**From:** [Donald E. Chamberlin](#)  
**To:** [Casey, Jonathan](#); [MCP-Chair](#)  
**Cc:** [Putman, Jim](#); [Faustini, Lou](#)  
**Subject:** Little Steps Daycare, Primrose at 16550 Georgia Ave  
**Date:** Monday, May 4, 2026 1:22:47 PM

The Patuxent Watershed Protective Association (PWPA) has reviewed the materials associated with the subject property development and has no objection to it, or to the associated parking variance for shared parking.

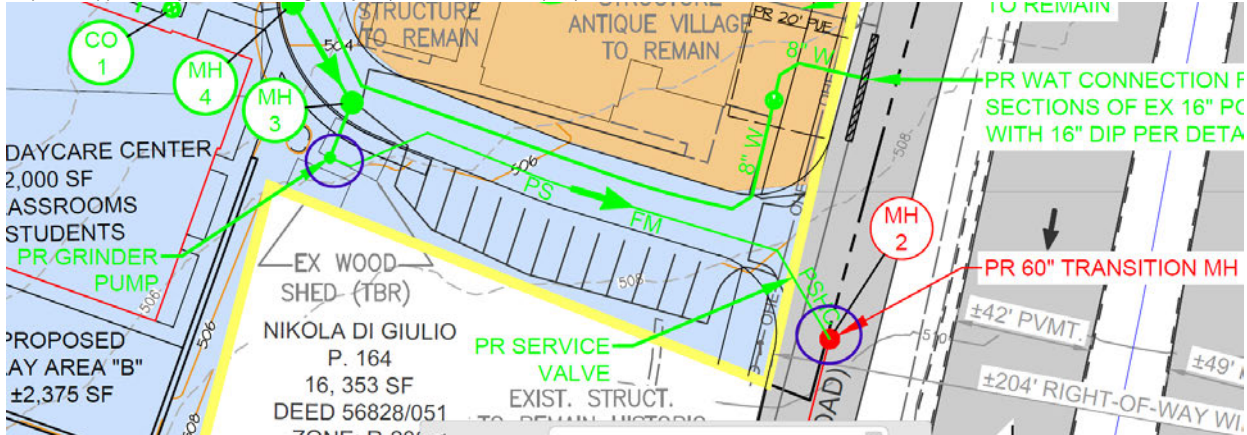
1. File 07-Prel-120250090-005.pdf V7 shows a 1.25" output pipe from the sewage grinder pump going slightly uphill to the gravity sewer along Georgia Avenue. Is a pipe of this size adequate to handle the combined seware outputs of both the antique store and the daycare facility. each of which has an 8" sewer pipe feed into the grinder? Presumably the day care will have much higher sewage inputs than the antique shop.
2. The Storm Water Management Plan indicates that because of the elevations on the site and other restrictive features, the stormwater management facilities will not be able to handle all the water from a 10 year (or, implicitly, greater rain volume) storm. The diagrams seem to indicate that the excess water will run off into the adjacent wetlands area. Is this correct? If so, PWPA has no objection. If not, how will the excess water be handled?

Thank you for the compliment on the staff report. As you know, we rely on the technical experts at WSSC and DPS to review the details of their respective plans, so I can't answer your questions with absolute certainty. However, based on the plans and my general understanding, the 1-1/4" pipe between the grinder pump and gravity sewer main (both circled in blue below) is a pressure sewer force main which requires a significantly smaller diameter pipe to convey slurry (waste) from point A to point B.

Snip from approved Hydraulic Planning Analysis (attached to staff report):
